# **VOL. 1: STANDARD DRAWINGS**

**Addendum No. 8**  
Published: January 2023

**ADDENDUM No. 8**  
TO THE  
CITY OF FRESNO  
PUBLIC WORKS STANDARD DRAWINGS AND SPECIFICATIONS  
ADOPTED MARCH 4, 1970, BY RESOLUTION NO. 70-36

P-72

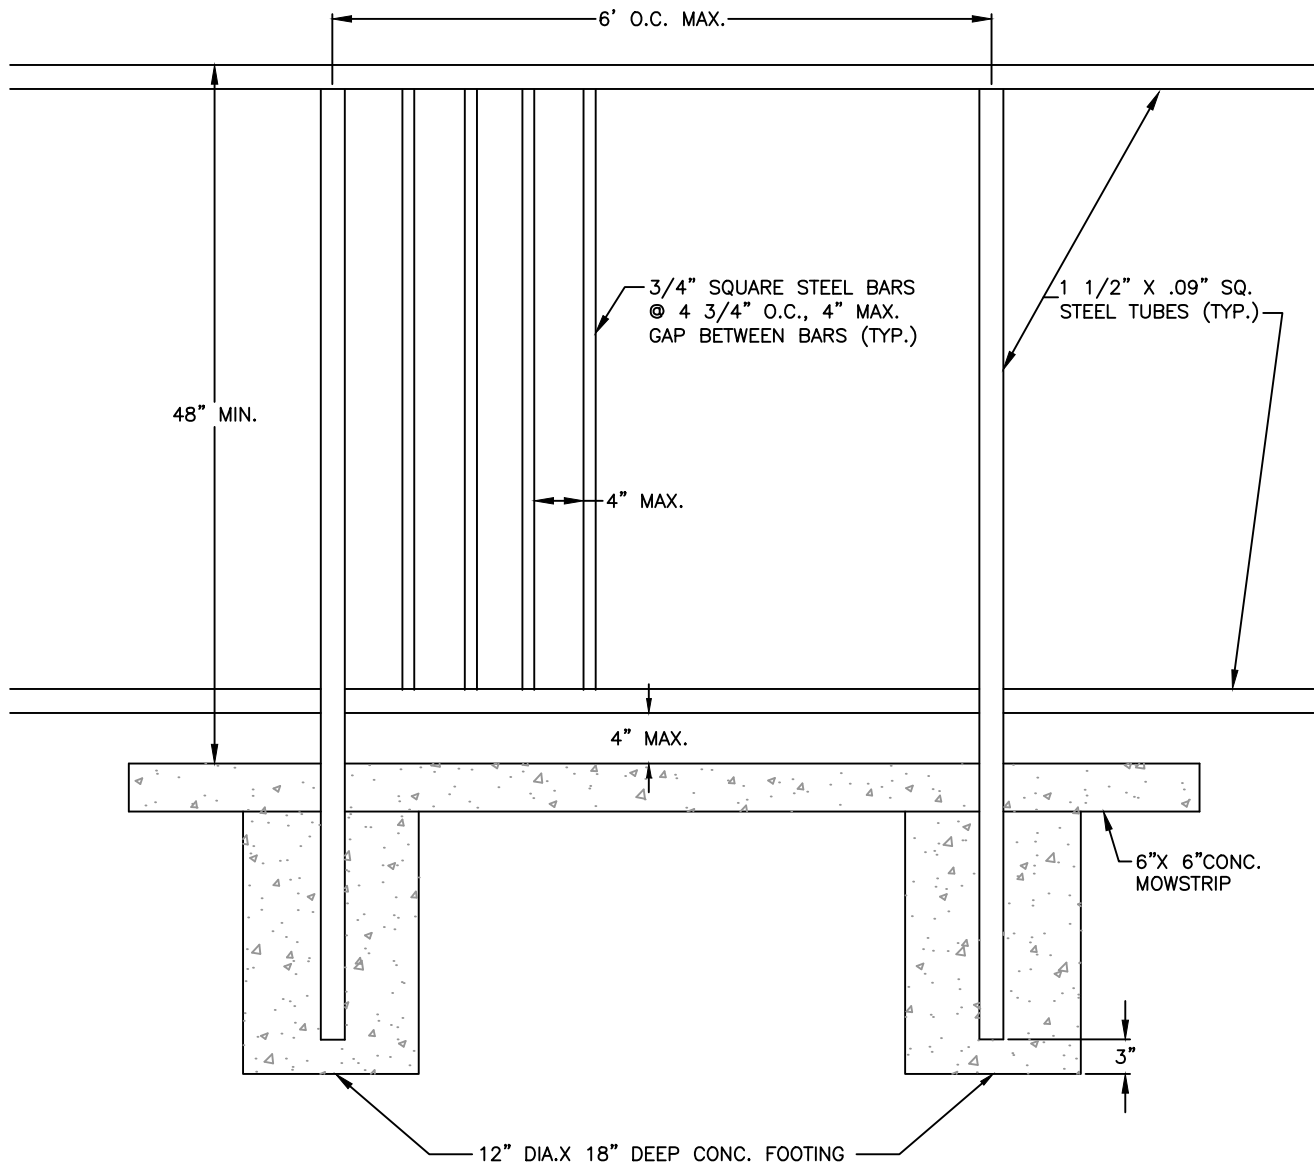
<b>P-72</b>	<ol style="list-style-type: none"> <li>1. <b>Renumbered</b> to FAX-1. Refer to that Standard Drawing for additional details and changes in this Addendum.</li> </ol>
<b>P-73</b>	<ol style="list-style-type: none"> <li>1. <b>Renumbered</b> to FAX-2; reinforced curb <b>detail moved</b> to FAX-4. Refer to those Standard Drawings for additional details and specific changes included with this Addendum.</li> </ol>

CITY OF FRESNO  
**E-1A**

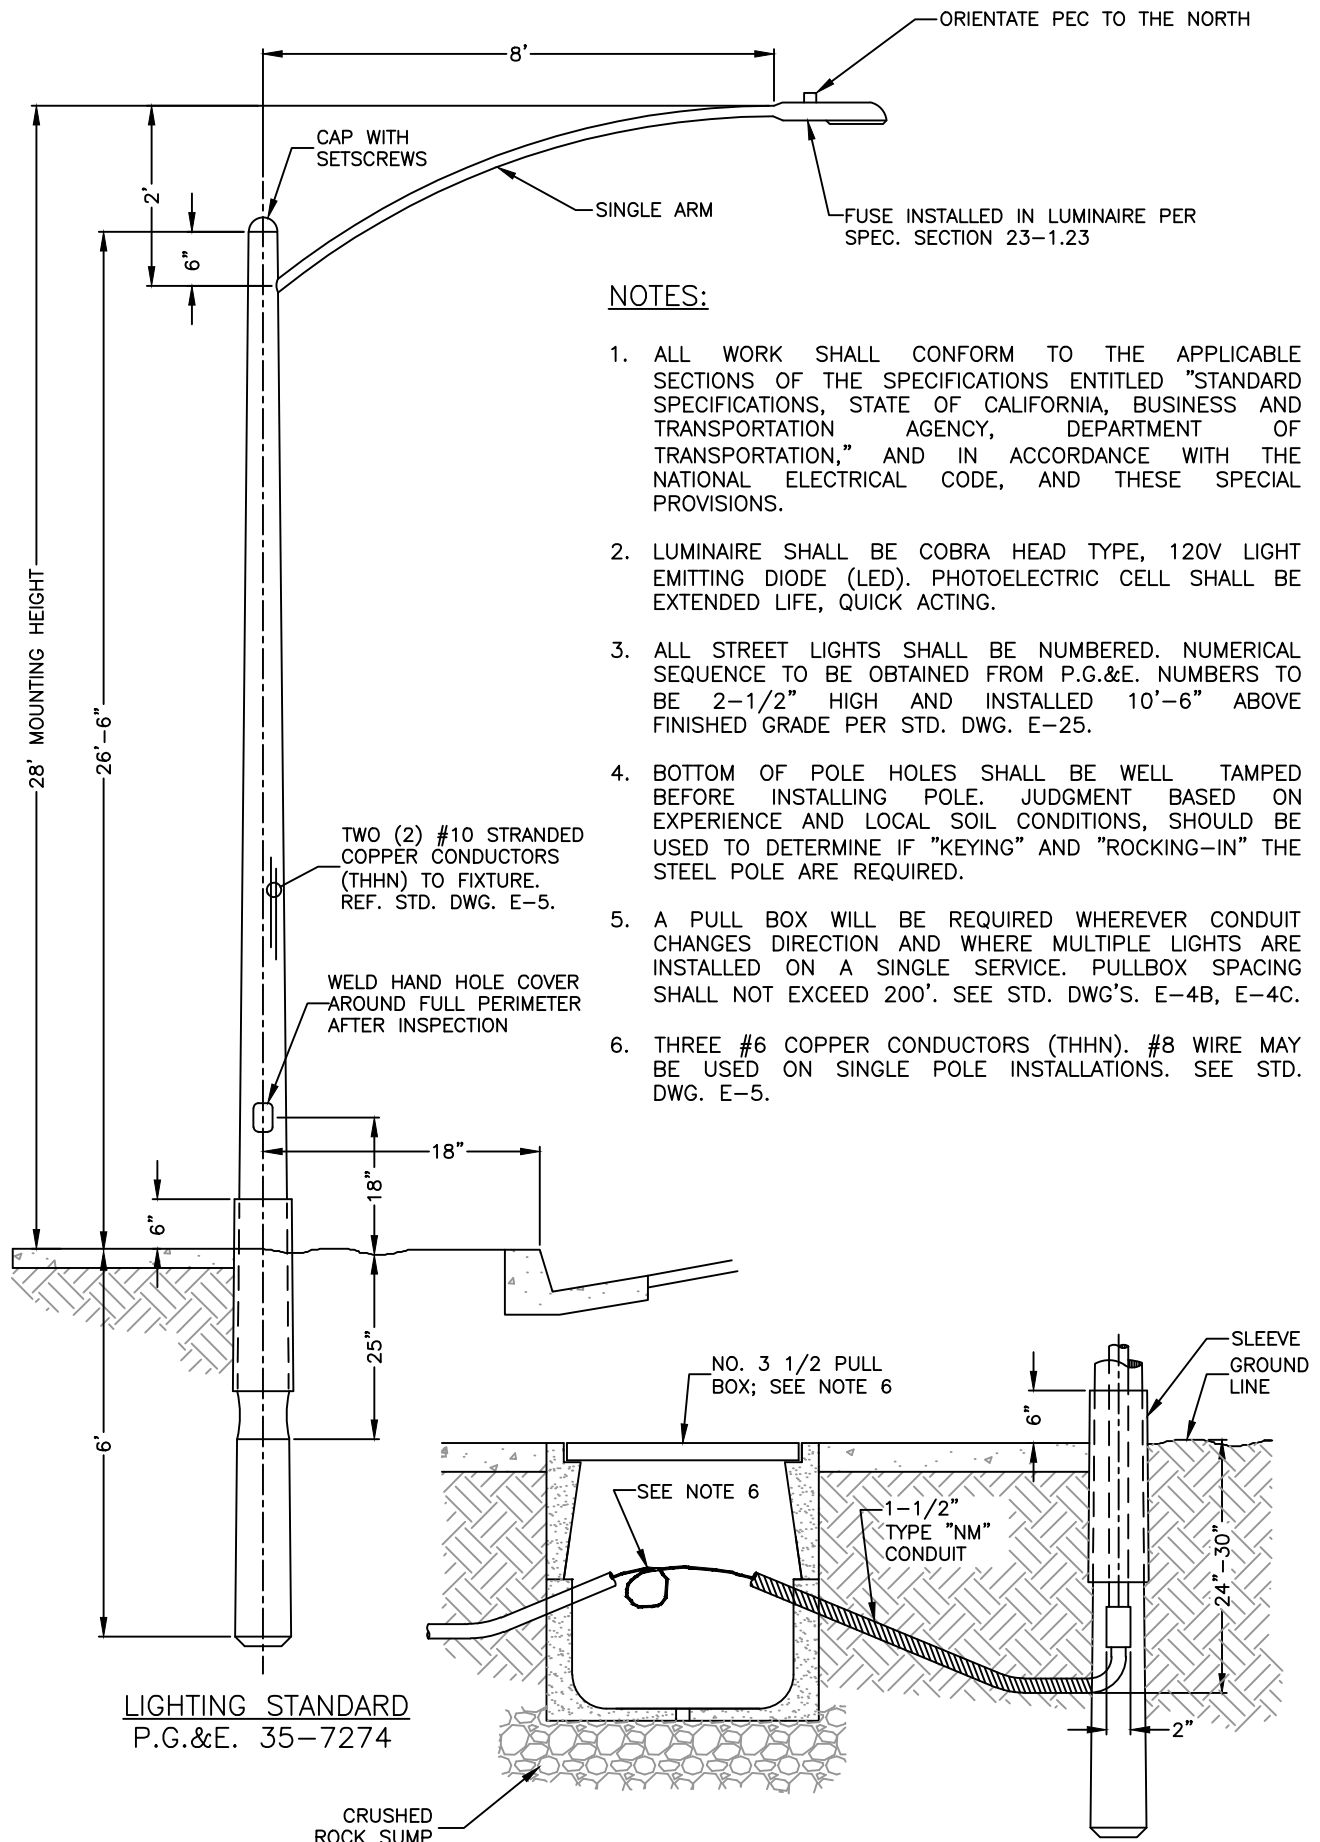
<b>DPW – ELECTRICAL</b>	
<b>E-1</b>	<ol style="list-style-type: none"> <li>1. <b>Minor changes to BASE DETAIL</b>, including clearer depiction of sidewalk concrete section and removal of linework and callouts referring to “FORMED” concrete.</li> <li>2. <b>Added callout</b> to BASE DETAIL: “SIDEWALK”.</li> <li>3. Added leader to “TOP OF FOUNDATION” callout.</li> </ol>
<b>E-1A</b>	1. <b>New Standard Drawing</b> , “STREETLIGHT – OVERHEAD FEED”.
<b>E-5</b>	<ol style="list-style-type: none"> <li>1. <b>Drawing modified</b> to depict/require all leads to be pulled/looped in the pole handhole.</li> <li>2. <b>Added note 2: “ALL CONDUCTORS SHALL BE PULLED INTO HANDHOLLE WITH 18” MIN. SLACK PROVIDED”.</b></li> </ol>
<b>E-27</b>	<ol style="list-style-type: none"> <li>1. <b>Standard Drawing title: “SIGNAL LIGHT FOUNDATION WIRE-WAY DETAIL” revised to read: “SIGNAL &amp; STREET LIGHT FOUNDATION AND WIRE-WAY DETAIL”</b></li> <li>2. <b>Drawing modified</b> to depict sidewalk, show entire foundation including anchor bolts and light pole base plate mounting.</li> <li>3. <b>Added detail: “ANCHOR CONNECTION DETAIL” and table</b> for min./max. offset between top of sidewalk and bottom of base plate.</li> </ol>

4. <b>Added various callouts</b> to base detail regarding materials and construction requirements.
--	--

CITY OF FRESNO  
S-5B

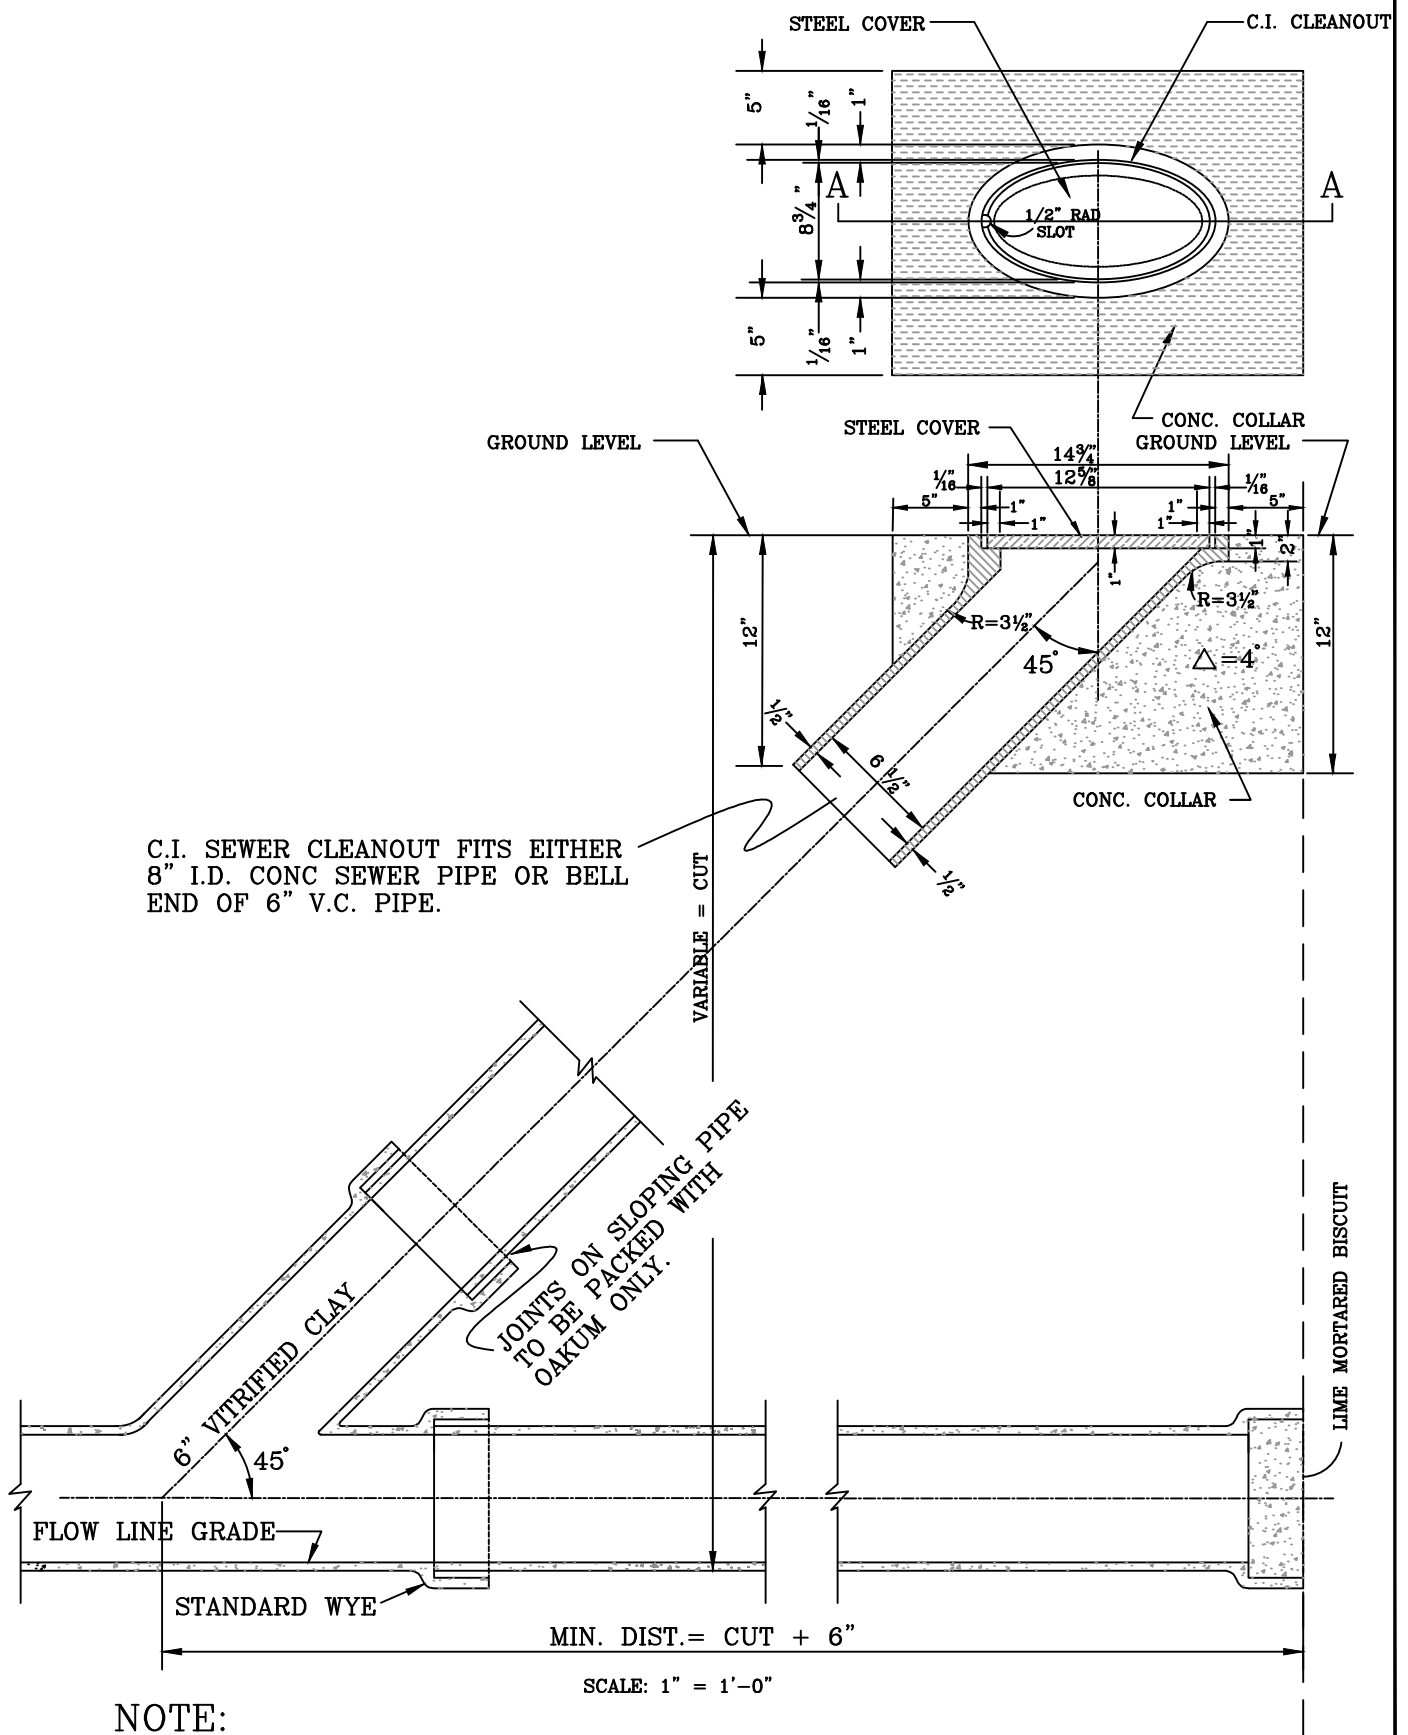
- S-5B** Added Note 8 regarding placement of manhole cover opening.
- S-7** Replace "S-7" with "S-7A and S-7B"
- S-8** Changed house branch Tee Fitting material to SDR35 to match uniform plumbing code  
Changed compression fitting to Gasket PVC Hub  
Added "Total gap not to exceed ½" note to ensure proper connection is made.
- S-9** Clarified Note 4 regarding maximum extension of the saddle into the sewer main.
- S-10** Replace "Ref. Std. Dwg. P-40" with "Ref. Std. Dwg. P-48"
- S-11A** Added note to "Min. Model Height" to address heights less than minimum.
- S-12** Correction to Note 2.

**CITY OF FRESNO  
RW-7**

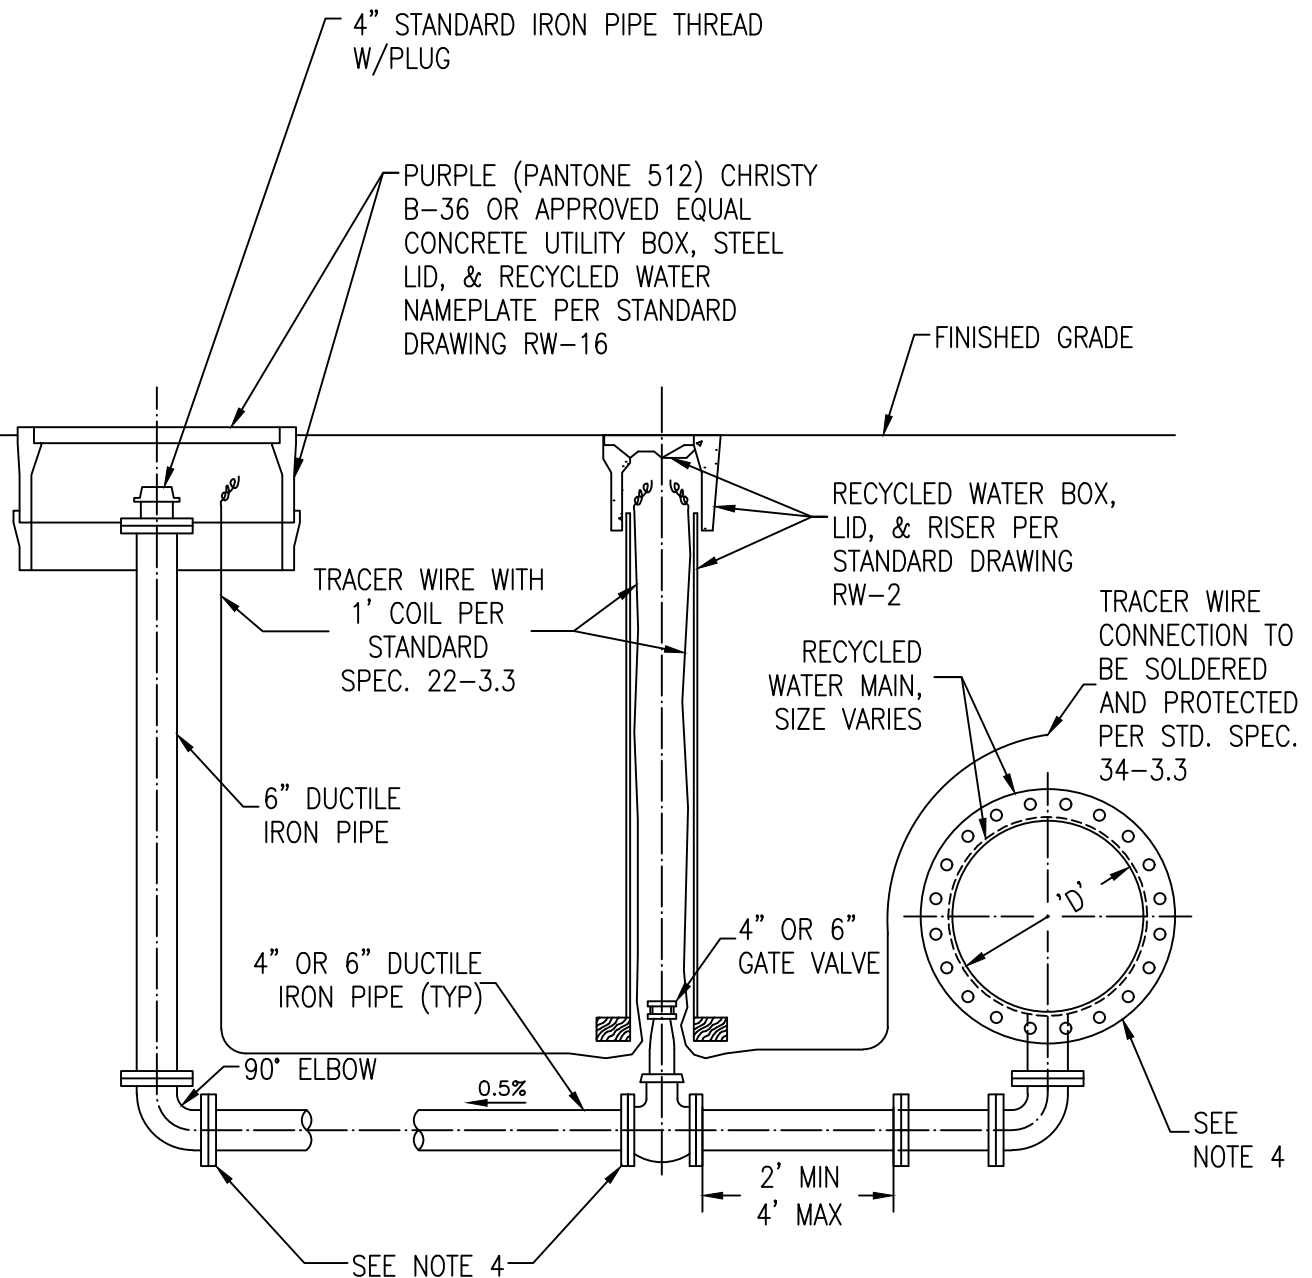
<b>RW-7</b>	<ol style="list-style-type: none"> <li><b>Callout</b>: "PURPLE (PANTONE 512) CHRISTY METER BOX WITH LID (17" X 30") AND MARKED WITH THE WORDS "RECYCLED WATER"" <b>Revised to read</b>: "PURPLE (PANTONE 512) CHRISTY B-36 OR APPROVED EQUAL CONCRETE BOX, STEEL LID AND RECYCLED WATER NAME PLATE PER STANDARD DRAWING RW-16"</li> <li><b>Callout</b>: "2" x REQUIRED LENGTH GALVANIZED STEEL PIPE TYPE "K" RIGID OR SOFT, CONTINUOUSLY WRAPPED WITH APPROVED PURPLE RECYCLED WATER MARKING TAPE" <b>Revised to read</b>: "2" x REQUIRED LENGTH GALVANIZED STEEL PIPE, CONTINUOUSLY WRAPPED WITH APPROVED PURPLE RECYCLED WATER MARKING TAPE"</li> <li><b>Callout</b>: "TRACER WIRE WITH 1' COIL PER STANDARD SPEC. 22-3.3" <b>Revised to read</b>: "TRACER WIRE WITH 1' COIL PER STANDARD SPEC. 34-3.3"</li> <li><b>Note 3</b>: "RESTRAIN ALL JOINTS PER SITY STANDARD SPECIFICATIONS SECTION 21-15.5" <b>Revised to read</b>, "RESTRAIN ALL JOINTS PER SITY STANDARD SPECIFICATIONS SECTION 33-14.5"</li> </ol>
